12. Development Permit Application No. 000398 for 1146 Caledonia Avenue

Subject: Development Permit Application No. 000398 for 1146 Caledonia Avenue

RE: 1146 Caledonia Avenue revised proposal for Official Community Plan Amendment, Rezoning and Development Permit Application.

Date: 3/17/2015 4:06:08 PM
 Drawn by: [signature]
 Checked by: [signature]
 Title: A2.01
 Scale: 1:50

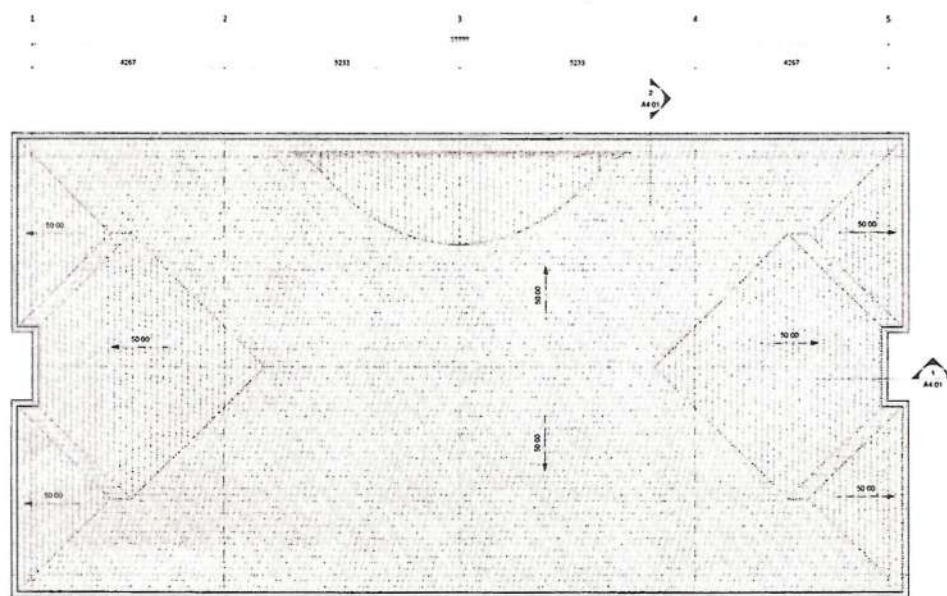
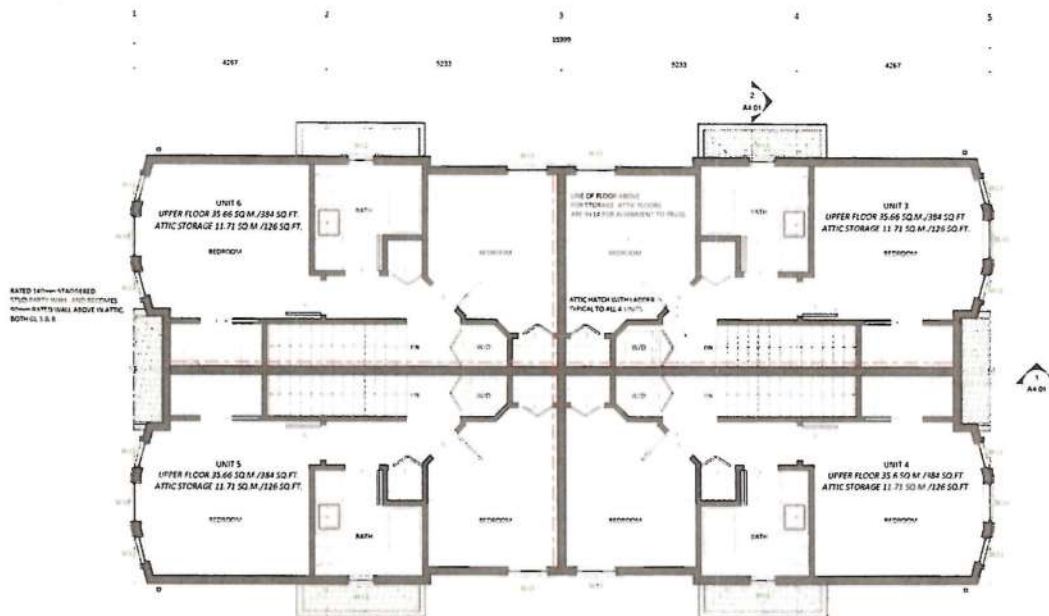
- a) Bicycle parking revised, shown on A0.00 and clarified in the Project Information Table.
- b) West exiting clarified and BCBC section referenced on A2.01.
- c) Outlook comparison provided on A4.03.
- d) Additional revisions are bubbled and itemized in attached document 'Revisions to Rezoning Submission' dated March 6, 2015.

- SECOND EXIT STAIR PROVIDED IN RESULT OF:
- 9.9.1. TRAVEL LIMIT TO EXITS OR EGRESS ROUTES
 1) EXCEPT AS PROVIDED IN SENTENCE (2) AND (3), EVERY DWELLING UNIT CONTAINING MORE THAN 1 STOREY SHALL HAVE EXITS OR EGRESS DOORS LOCATED SO THAT IT SHALL NOT BE NECESSARY TO TRAVEL UP OR DOWN MORE THAN 1 STOREY TO REACH A LEVEL SERVED BY
